Sundry Print Report

Well Name: PUBCO APACHE

Type of Action: Plug and Abandonment

Attachment to notice of Intention to Abandon

Proposed Wellbore Diagram
DJR Operating, LLC
Pubco 3
API # 30-039-05063
NW/SE, Unit J, Sec 16, T23N, R2W
Rio Arriba County, NM

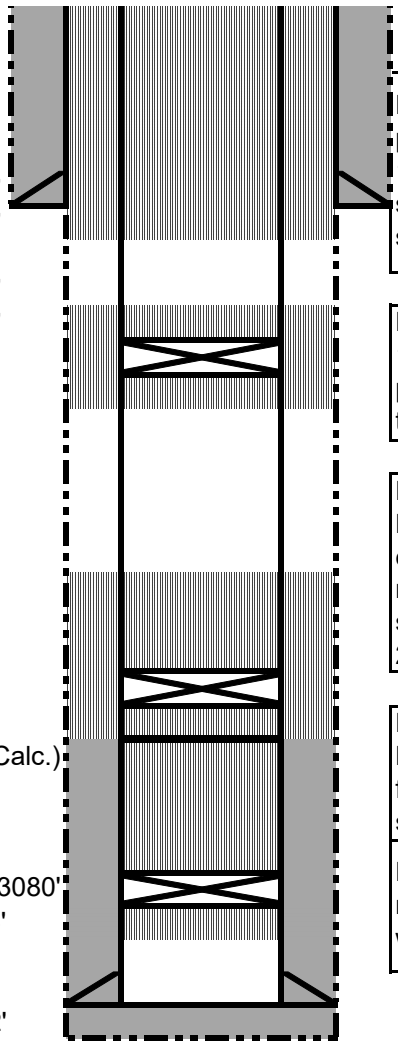
You are also required to place cement excesses per 4.2 and 4.4 of the attached General Requirements.
